# COAL BURNER REGISTER, NOZZLES AND LIGHTERS INSPECTION

|       | COCK & Wilcox<br>McDermott company              |                            |
|-------|---|----------------------------|
| Cust. | INTERMOUNTAIN POWER                             | File No.<br>or Ref. RB-614 |
| Subj. | BURNER INSPECTION                               | Date MAY 22, 1987          |

| CUSTOMER | INTERM | 10CIMSTAI | U POWER     |                  | JOS No. | RB-614 |
|----------|--------|-----------|-------------|------------------|---------|--------|
| SUBJECT  | THROAT | SLEEVE    | ATTACHMENTS | · <del>S</del> - |         |        |

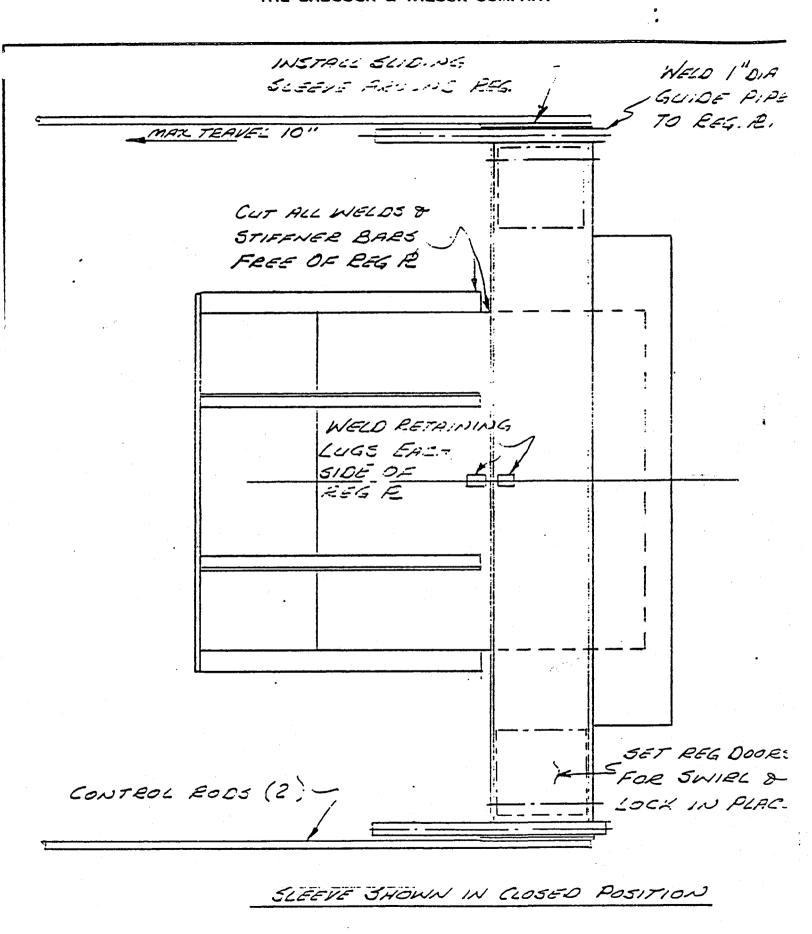
- 1. Most of the burners have failed welds attaching throat sleeve to the register plate.
- 2. The throat sleeve on many burners are barrel shaped. This will not effect the functional operation of the burner.
- 3. Corrective repair for attachment must be made. See attached sketch.
